NUREG/CR-4374
BNL-NUREG-51917
Vol. 2

A Review of the Oconee-3 Probabilistic Risk Assessment

External Events, Core Damage Frequency

Brookhaven National Laboratory

Figure 3.10 Comparison of the 1976 and 1982 USGS studies and the mean Oconee seismic hazard curve.

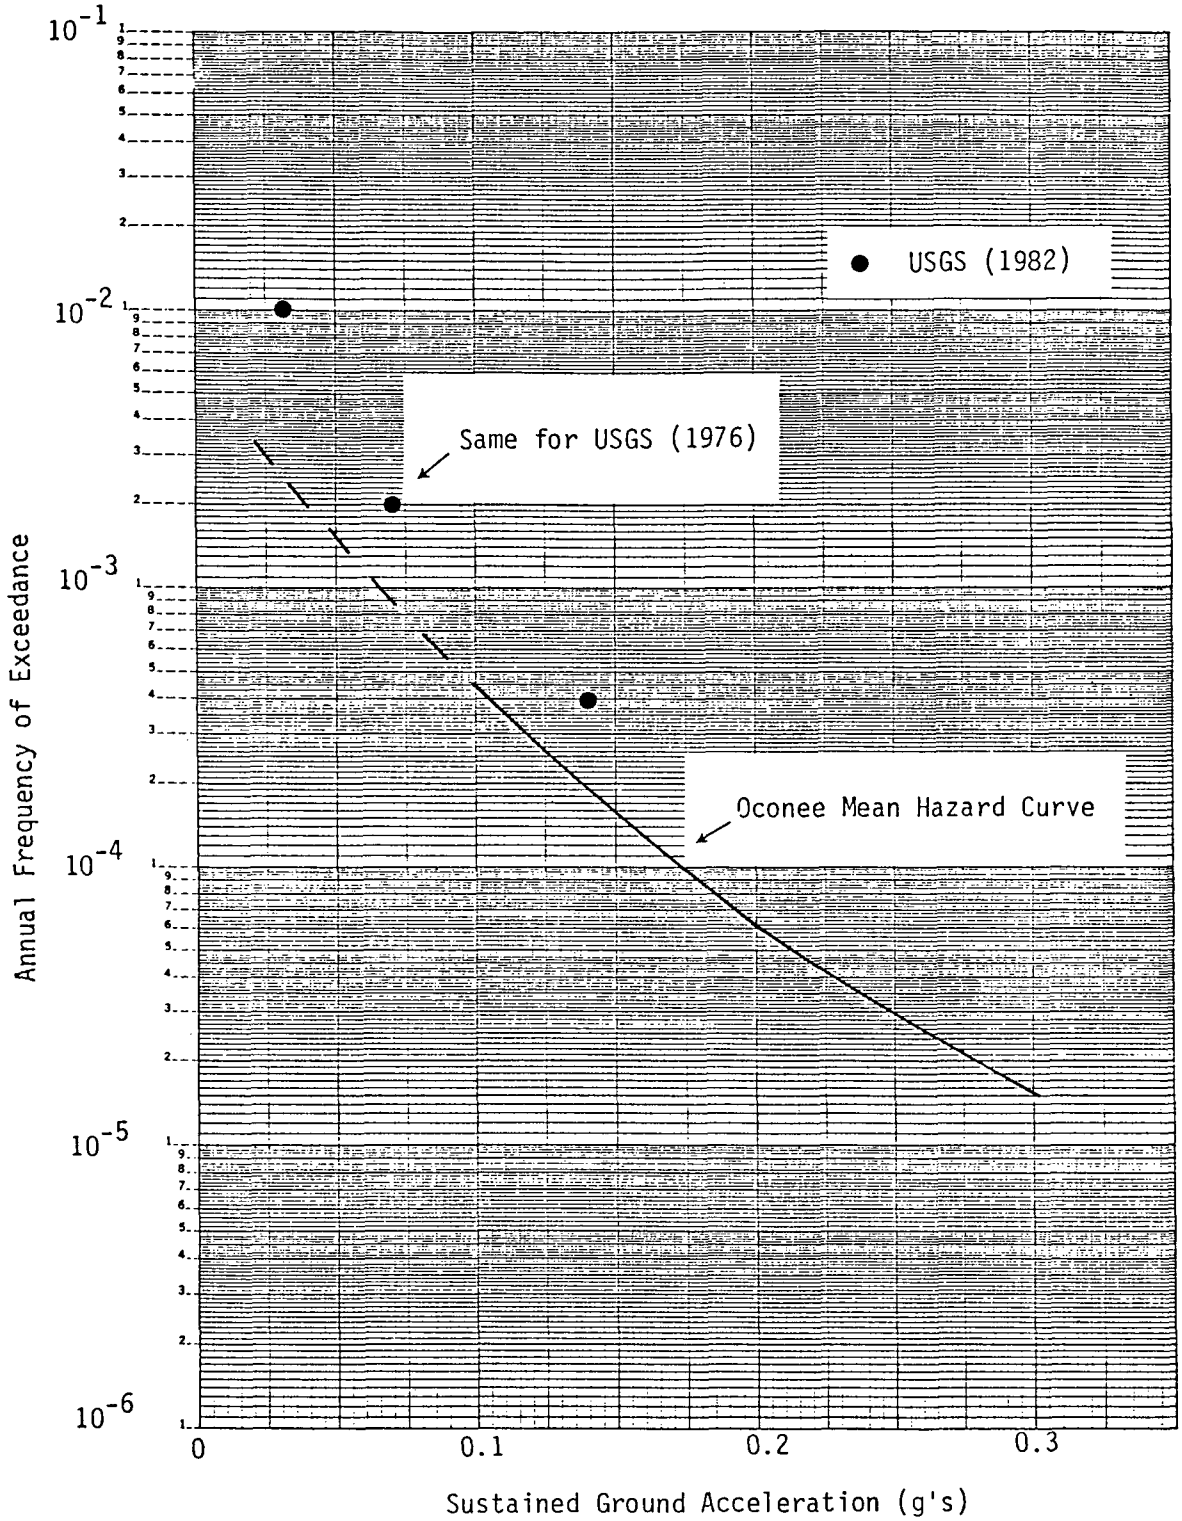
Figure 3.10 compares the USGS 1976 and 1982 hazard curves with the mean Oconee hazard curve. It is difficult to make a true qualitative comparison between these studies since the USGS studies do not account for the variability in ground motion. If they had, their results would be higher.

Figure 3.11 Comparison of cases 1 and 2.

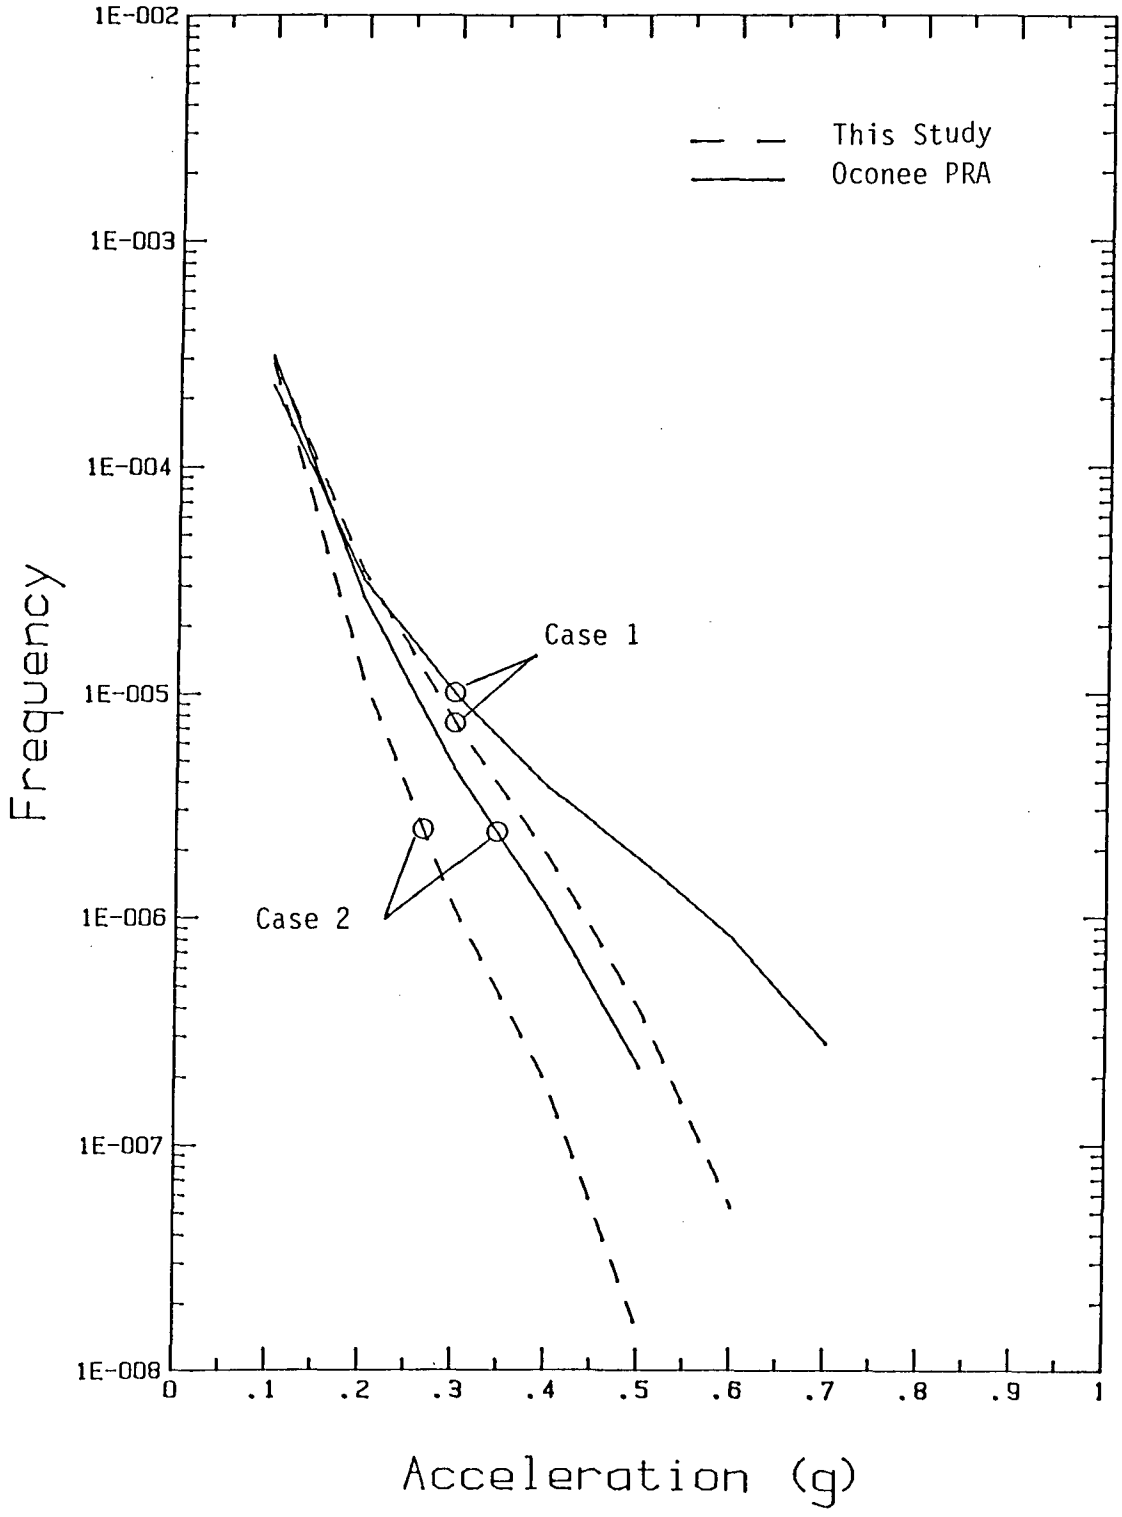
The results of our calculations and those reported in the OPRA are shown in Figure 3.11 in terms of sustained ground acceleration. From the figure it can be seen that beyond 0.40g, there are differences of greater than a factor of 2 between the two estimates for case 1 (i.e., OPRA and this study). For case 2, there is a factor of 2 difference at 0.20g's. Note that the Oconee hazard estimates are higher.

These findings were discussed with the author of the Oconee hazard analysis. In this discussion we first confirmed that the input to our calculations were correct. It is unclear, from the results reported in Figure 3.11 and our discussions with the analysts involved in the Oconee study, exactly what truncation level was used in the Oconee calculations. We understand that possibly a truncation at greater than two standard deviations was used, although this could not be confirmed. Secondly, it was learned that the seismic hazard results reported in Table 3 of the Oconee hazard report are smoothed values. The ill effects of this smoothing, which was greatest near the truncation limit, are apparent in case 1. From the results of our hazard computations, we find that only the Piedmont and Upper Coastal Plain source area contribute to the results for accelerations greater than 0.50g. Therefore, the truncation of the hazard curves is limited by the maximum intensity in this source area (i.e., MMI = VIII). From Table 3.3, the limit on acceleration is 0.681g; therefore, beyond 0.681g the frequency of exceedance should be zero. The Oconee hazard curve at 0.70g has a frequency of exceedance of 2.8E-7, which is incorrect.

Figure 3.12 Comparison of cases 1 and 2 results using a three standard deviation truncation.

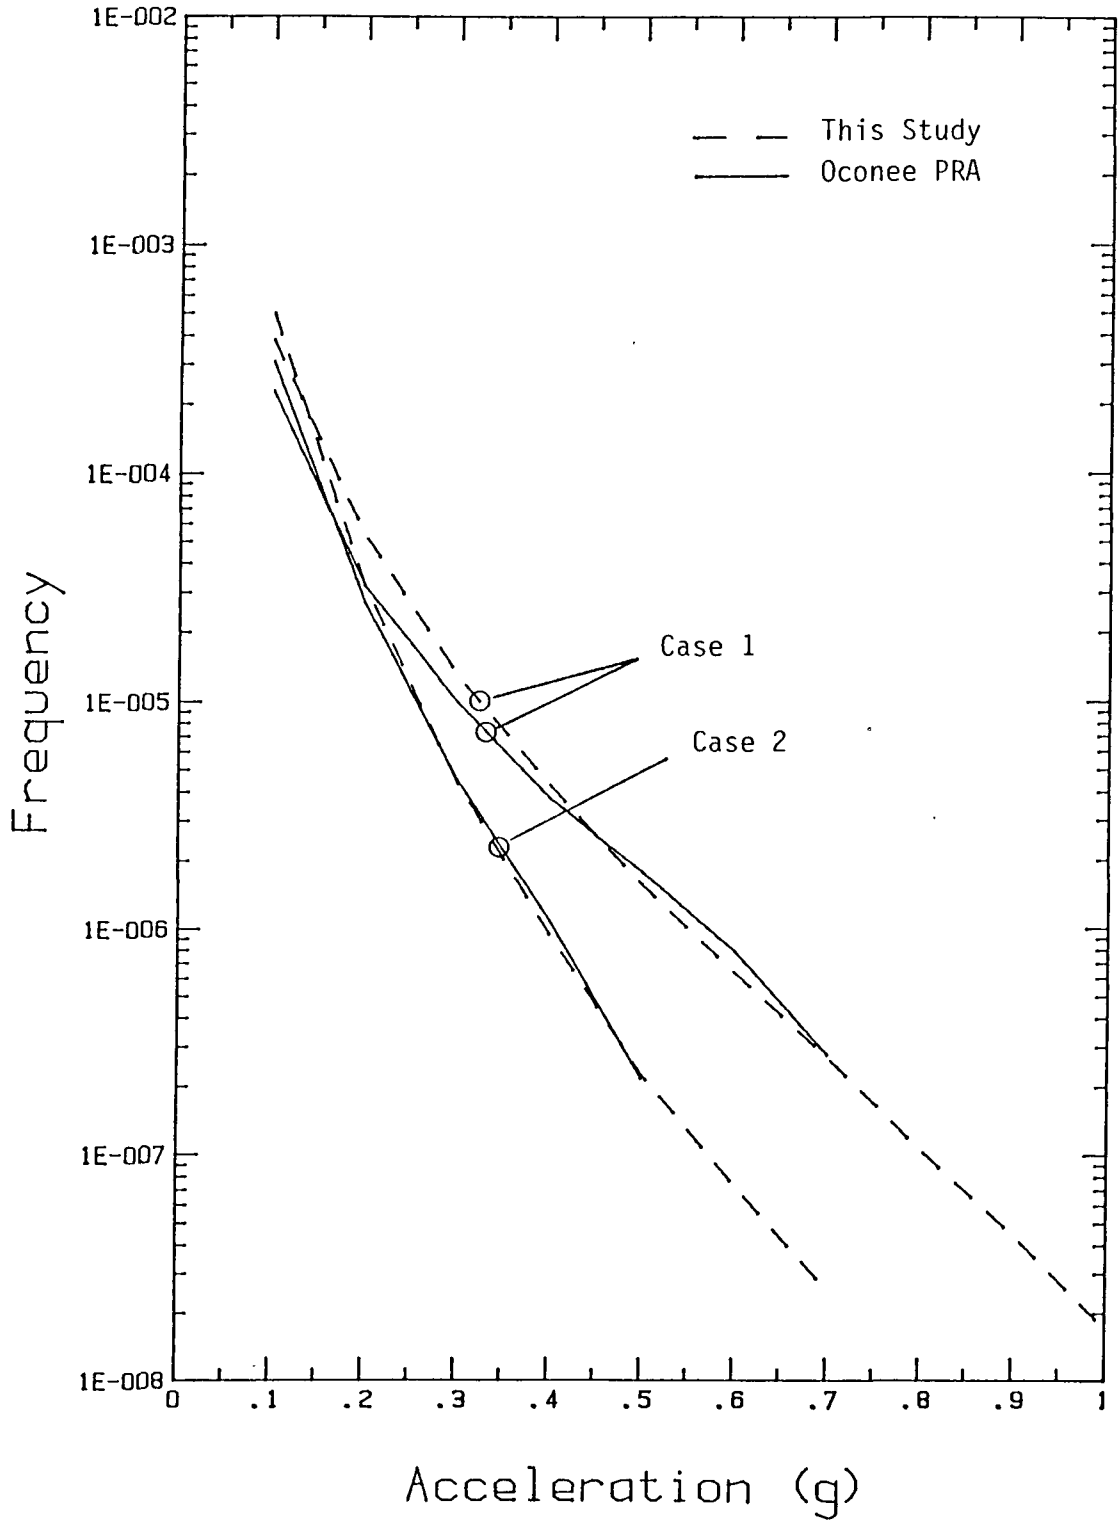
To reconcile our calculations with the Oconee results for cases 1 and 2, a three standard deviation truncation level was used. Figure 3.12 shows this comparison. For accelerations <0.70g, the results are reasonably close. Above 0.70g, the results are not as favorable since the truncation level is higher for a three standard deviation cutoff.

Figure 3.13 Comparison of cases 1 and 2 using a five standard deviation truncation.

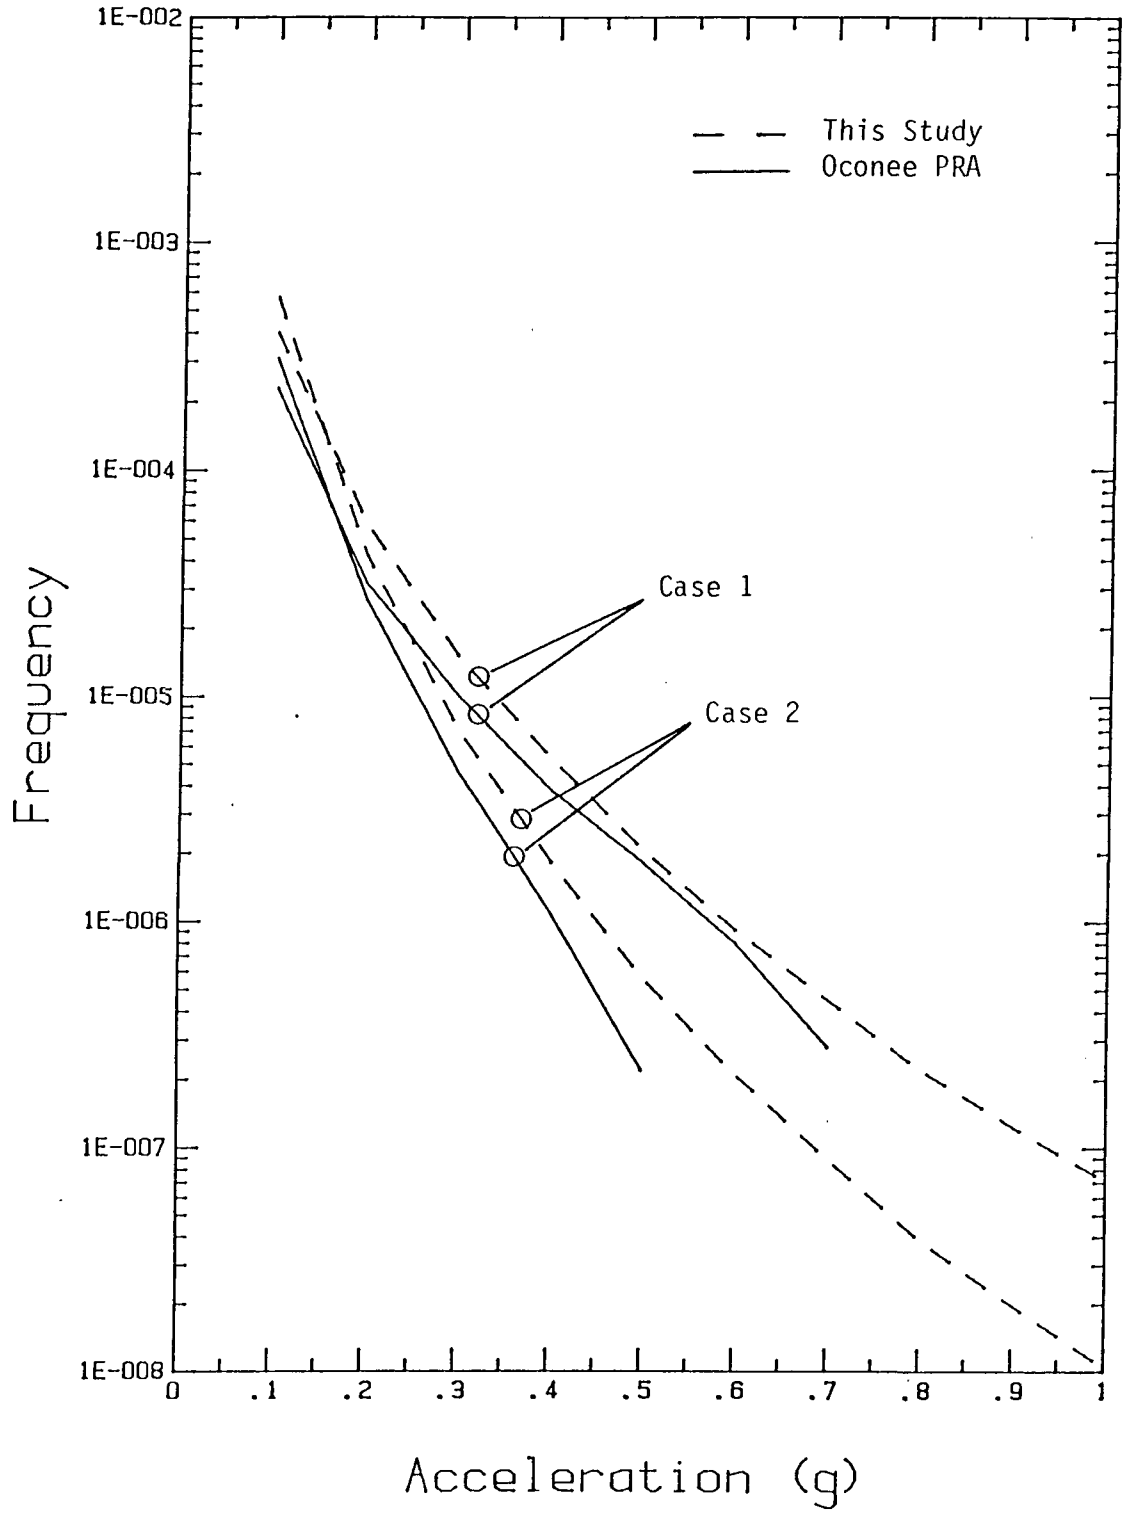
In Figure 3.13, a much higher truncation level of five standard deviations is considered for cases 1 and 2 and are compared to the Oconee results. Using a higher truncation limit produces hazard curves two to three times higher for case 1 and less for case 2. This suggests that for accelerations less than 0.40g, the effect on the hazard results of applying a truncation on acceleration is small.

Figure 3.14 Comparison for cases 1 and 2 hypothesis 1, I_{max} = VIII for the Piedmont and upper coastal plain source.

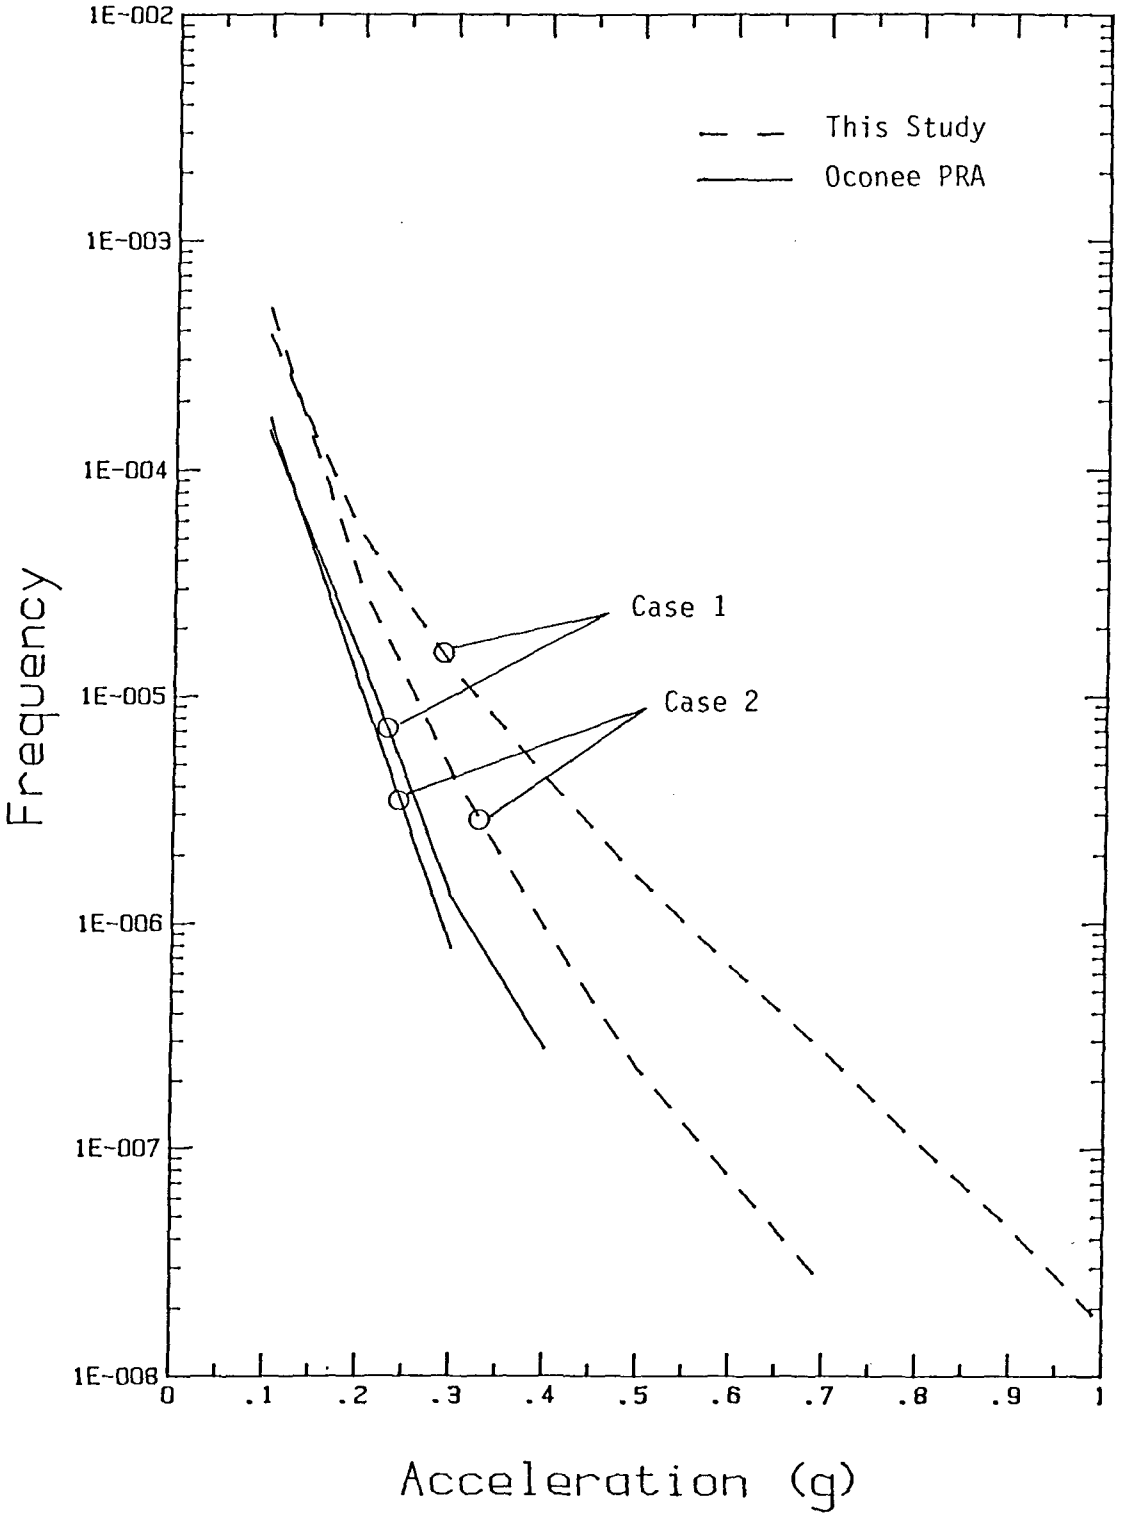
As part of our review, it was stated that the maximum intensity for the Piedmont and Upper Coastal Plain source area for all three hypotheses may be underestimated by one intensity unit. Figures 3.14 to 3.16 compare the effect of increasing the maximum intensity for cases 1 and 2, one unit for each hypothesis on the maximum size earthquake. For the Piedmont and Upper Coastal Plain source, the following revised estimates are made:

For accelerations beyond 0.30g, the difference increases to as much as a factor of 10 (see Figure 3.14). The largest differences are realized for hypothesis 1, while for hypotheses 2 and 3 the largest variations are less than a factor of 5.

Figure 3.17 OPRA seismic event tree.

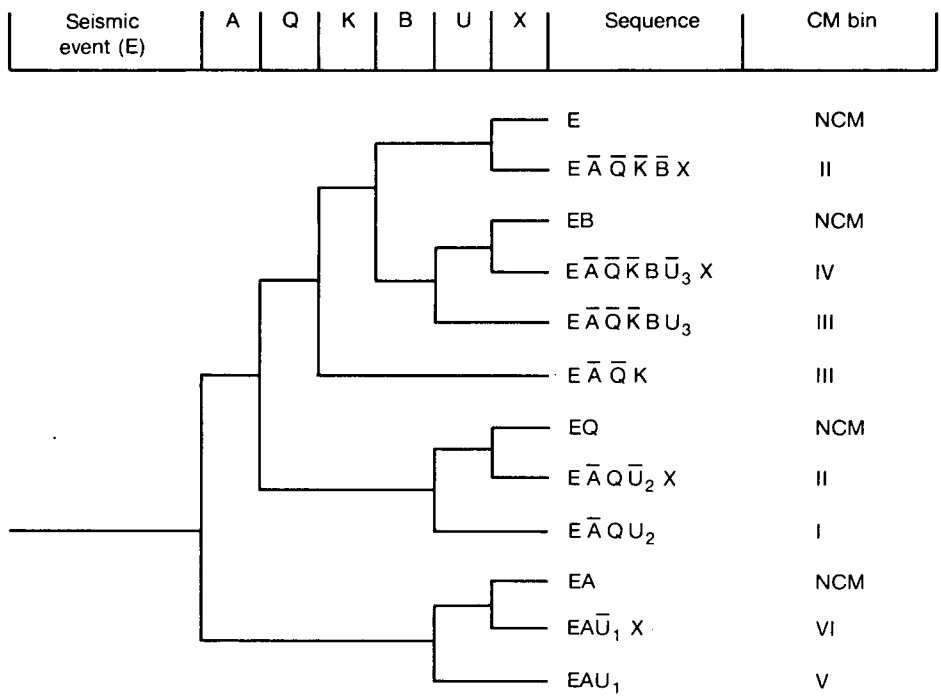
- Seismic Event Tree: This review is in agreement with the delineation of the seismic event tree presented in tne OPRA (Figure 3.17).

Figure 4.2 OPRA event tree for sequences initiated by a severe tornado.

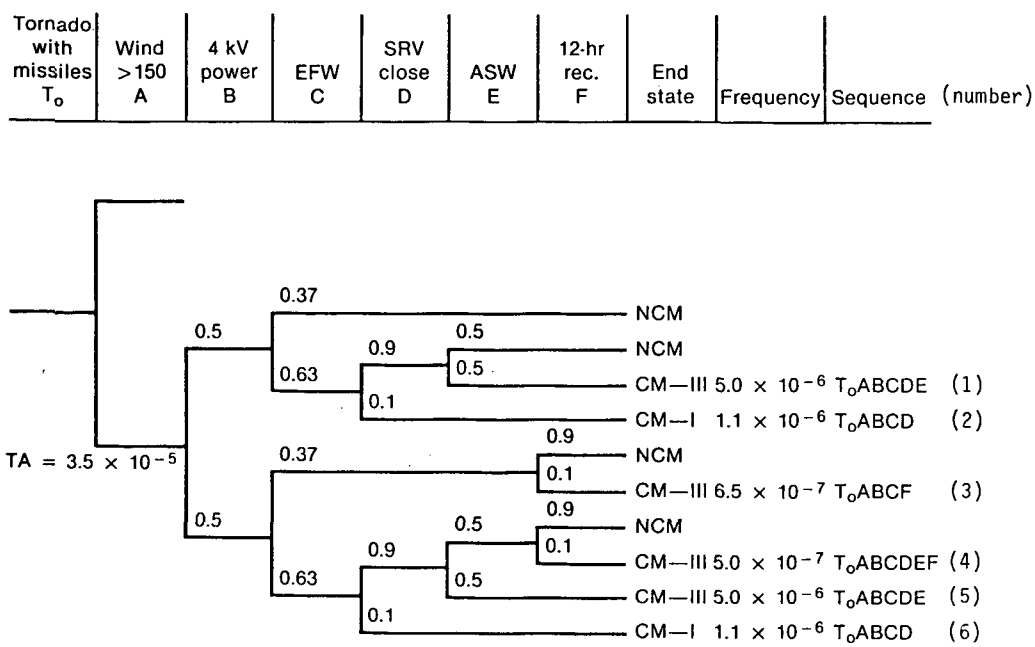
- Using the assumptions above, BNL reviewed the event tree. It is the reviewers' opinion that given a loss of 4-kV power (event B in Figure 4.2), seal leakage will occur (loss of makeup and loss of component cooling). Thermal barrier cooling is lost when component cooling is lost. Additionally, seal injection fails because HPI is not available (loss of 4-kV power and loss of BWST) and because the possibility of makeup from the SSF is also lost as the result of tornado damage to the west penetration room (see OPRA page 9-60, event F). Implications of these failures have been discussed in internal events treatment, where it is shown that core damage will occur in several hours. Note that loss of the BWST means that the seal LOCA cannot be mitigated

even if 4-kV power is restored before core uncovery. Therefore, sequences 3 through 6 in Figure 4.2 are substituted by the sequence T_0AB, which is a bin I sequence with a frequency equal to 1.7 x 10^{-5}/yr. The following revised core damage frequencies are then obtained:
